From: Jill Bastow
Sent: 06 September 2017 11:29
To: Planning
Subject: Fwd: NYM/2017/0433/FL - Midstream Cottage, Thornton le Dale
Attachments: 04 F Proposed Floor Plans and Elevations.pdf

Project: Extension and refurbishment
 Midstream Cottage, Thornton le Dale
 for: Mr. & Mrs. D. Shaw

Drawing title: Proposed Floor Plans and Elevations

WG477 - 04 F

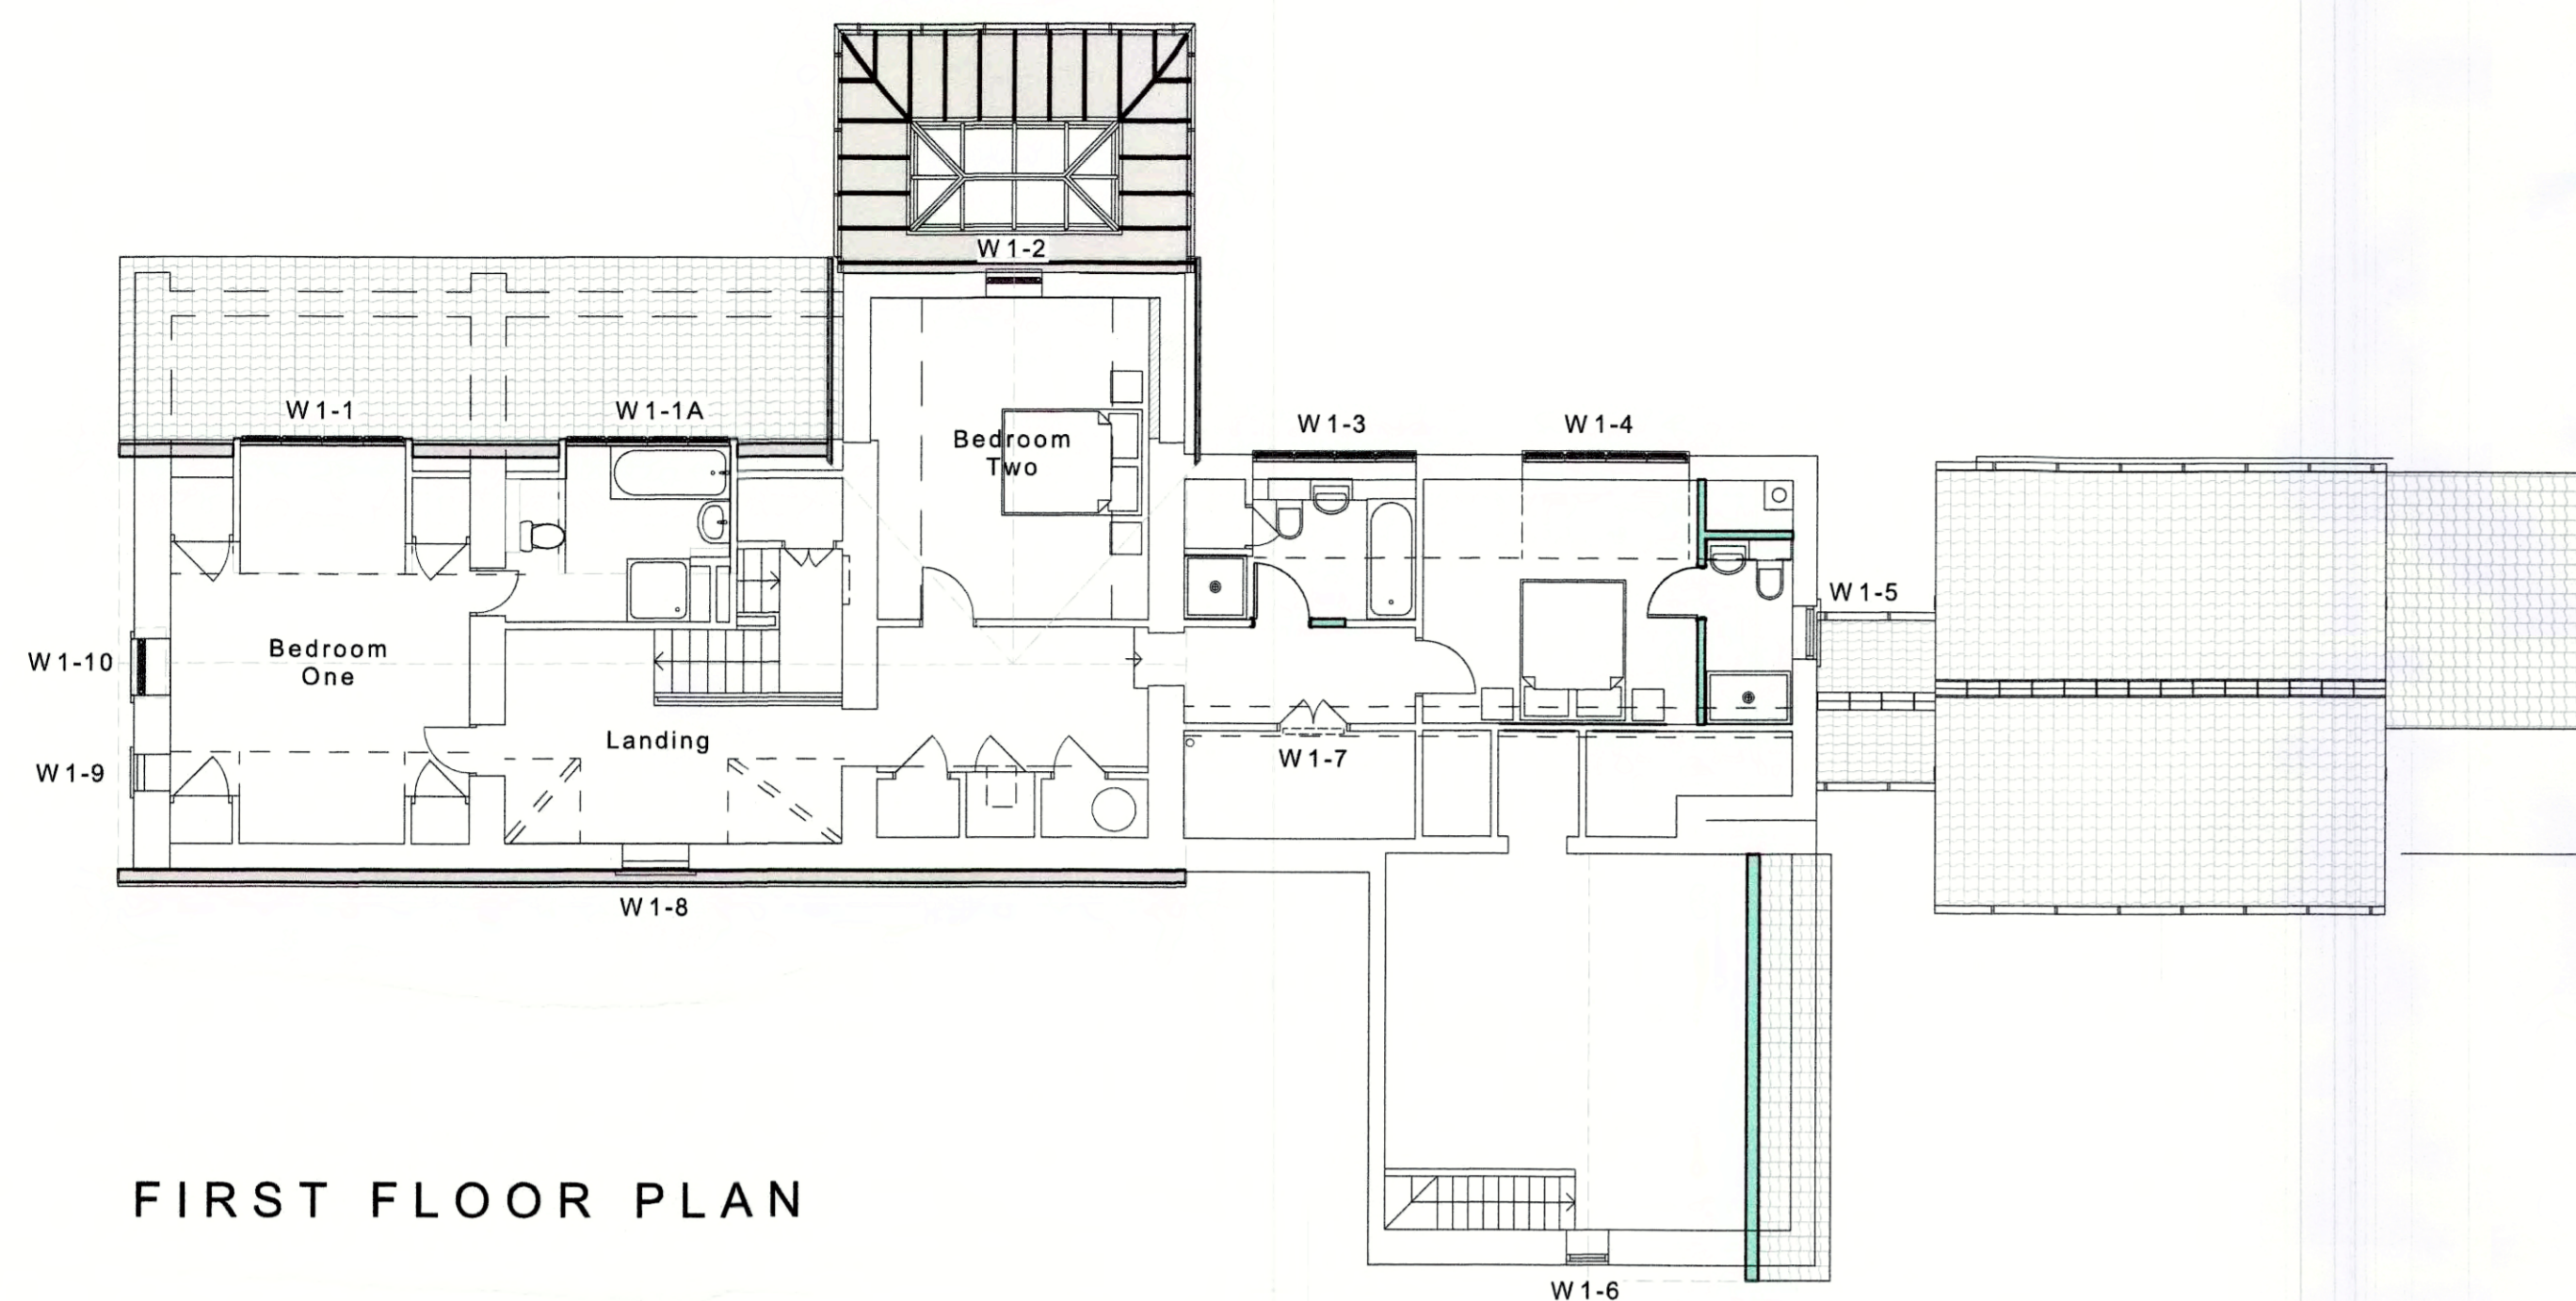
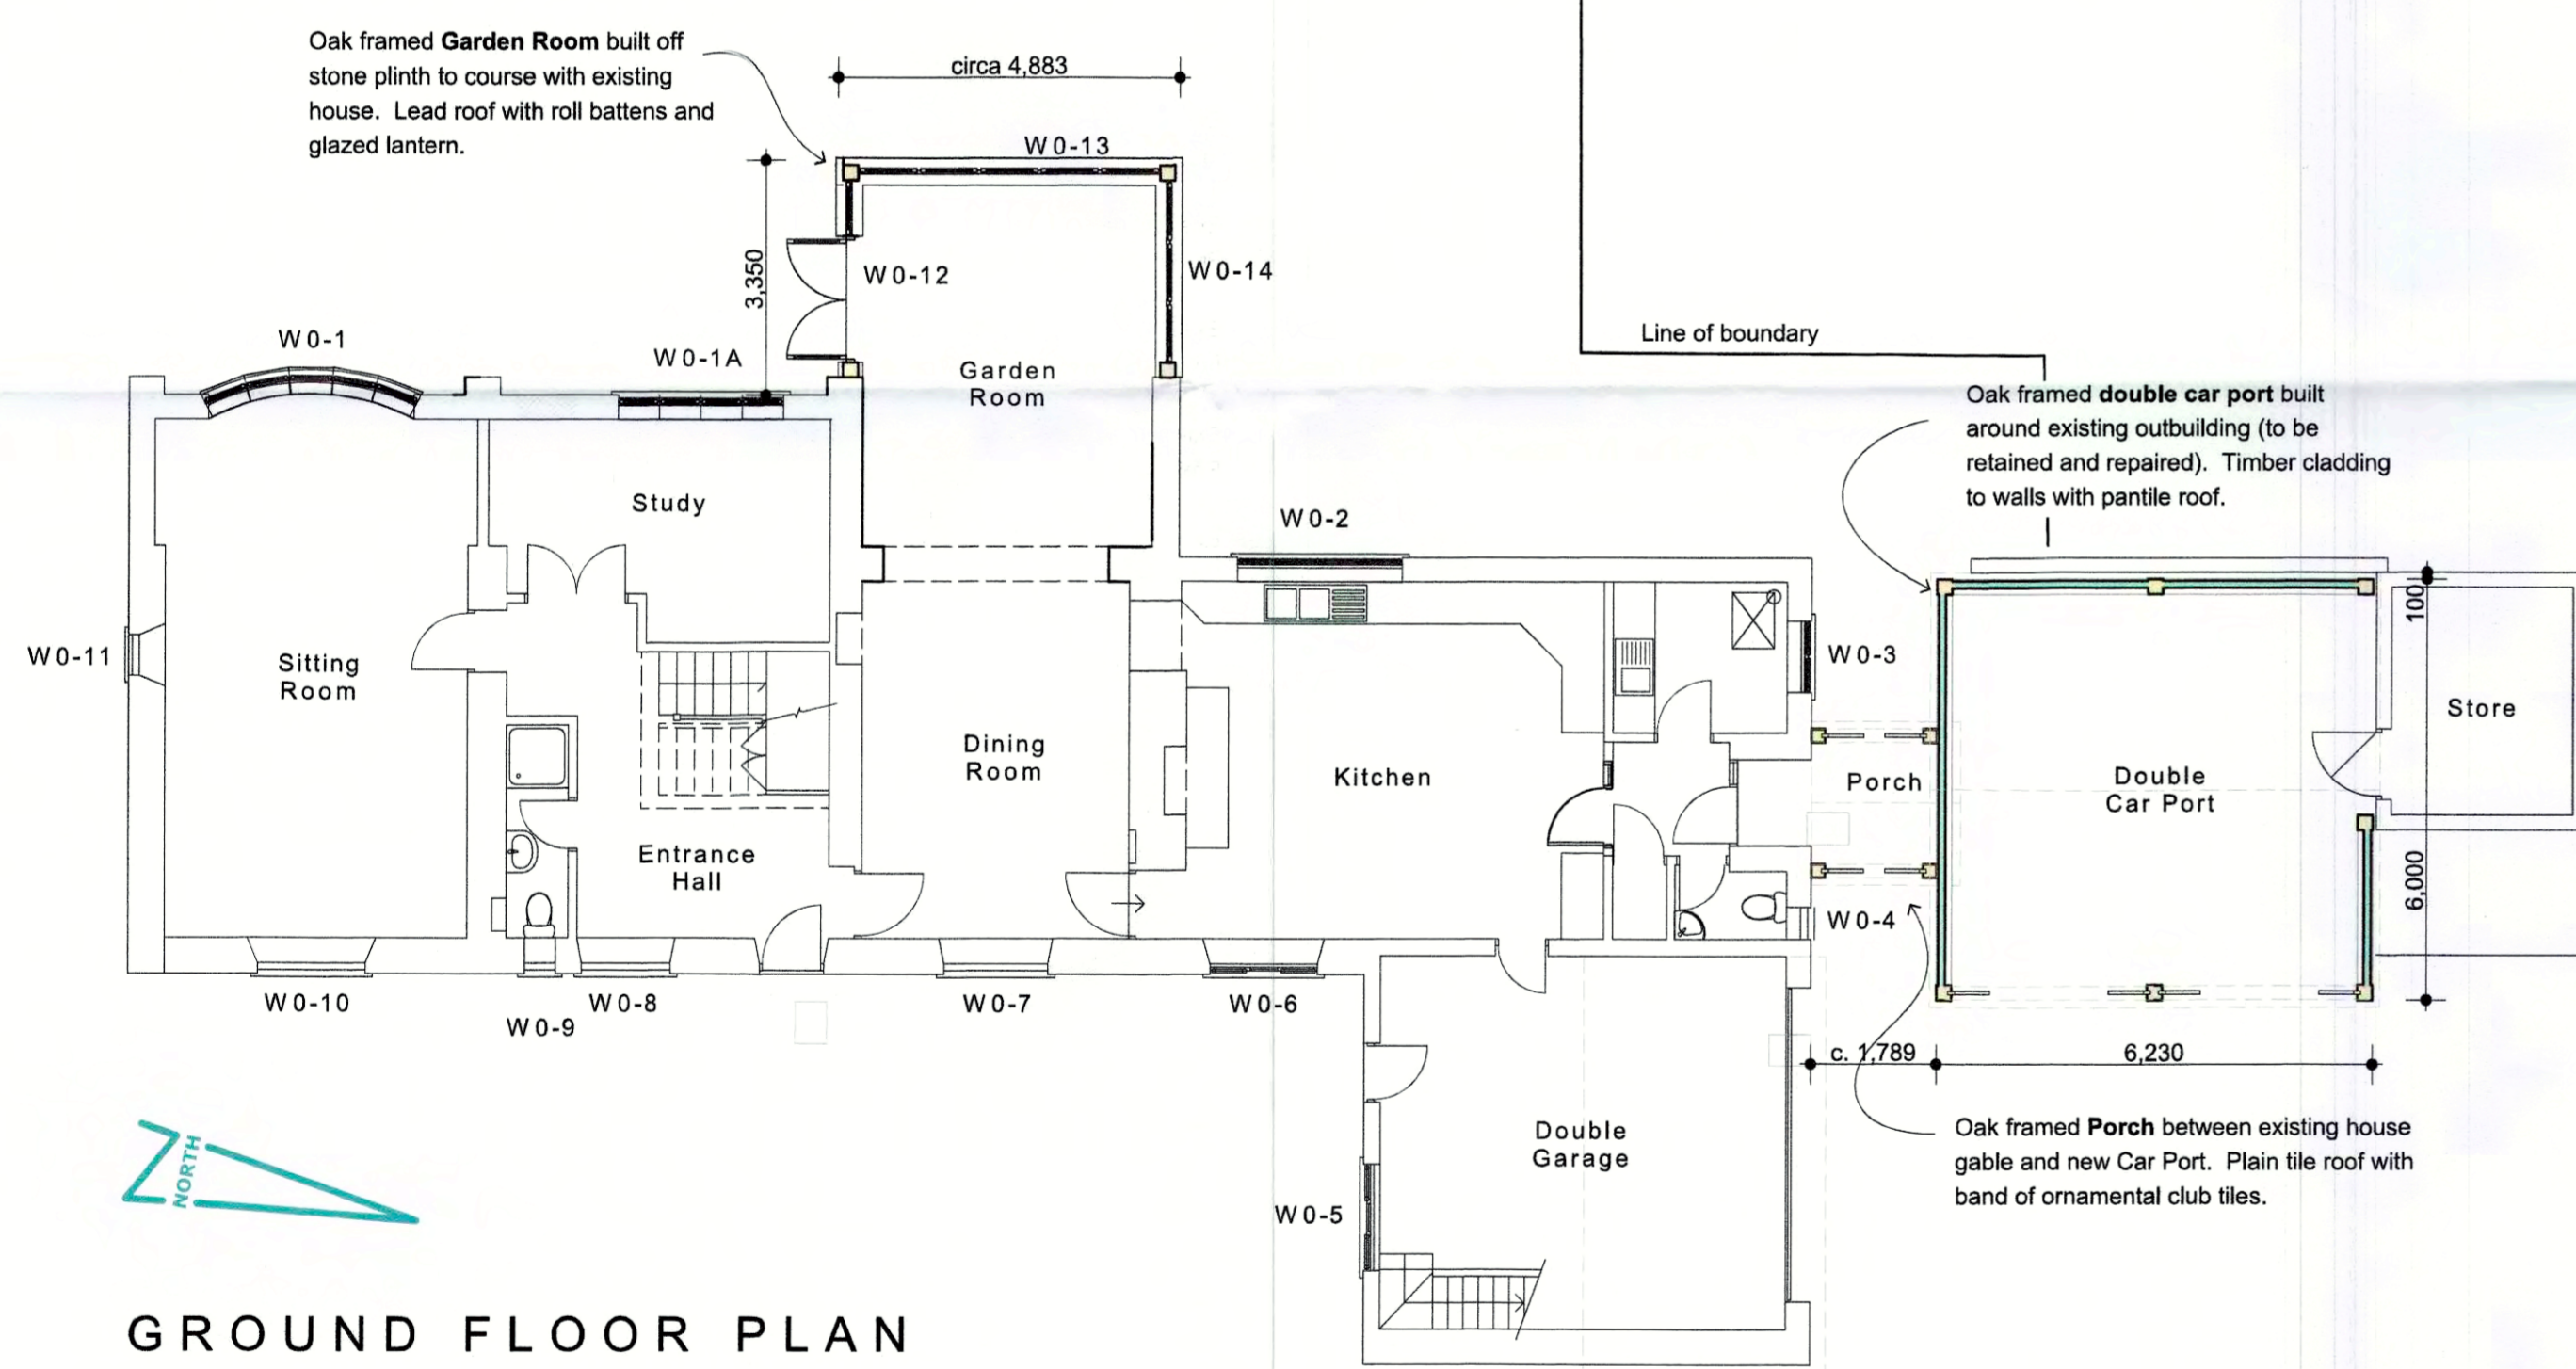
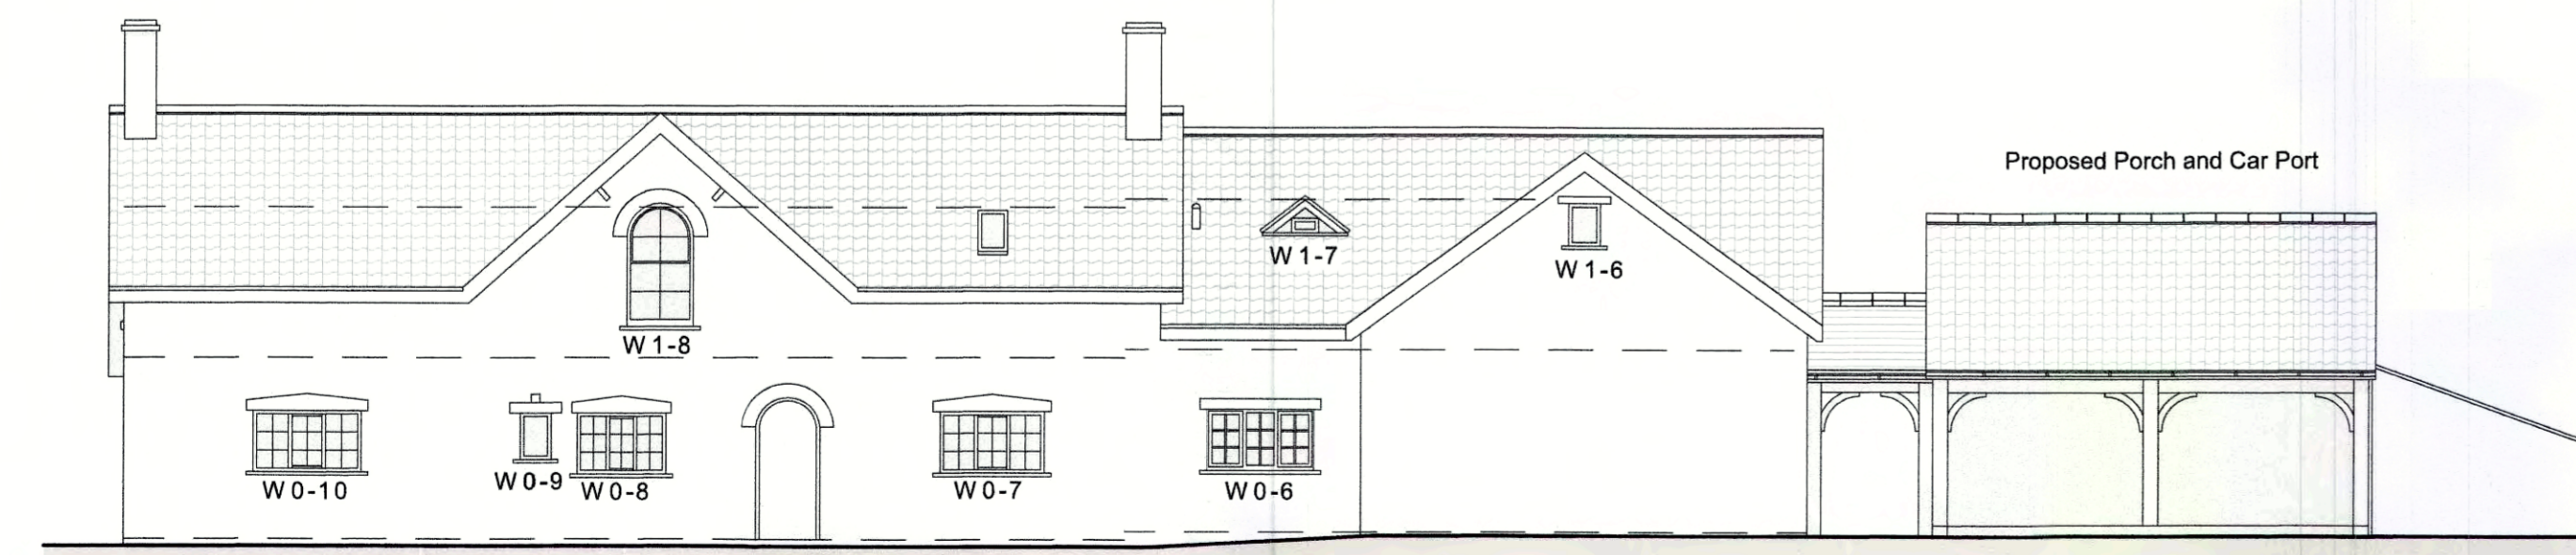
I've revised the proposal drawing (attached) to simply revert to an arched head window to the Bedroom in place of the Venetian. This is the original option we applied for and better compliments the gable. I trust this is acceptable.

- rev. A Design options prepared in response to pre-application enquiry comments.
- rev. B (23.05.17) Revised to Client preferred scheme.
- rev. C (05.06.17) Study external door removed.
- rev. D (02.08.17) Window references added.
- rev. E (01.09.17) No roof window omitted from existing Garage. Venetian window added (ref. W1-1).
- rev. F (06.09.17) Venetian window reverted to arched head only at Case Officer request (ref. W1-2).
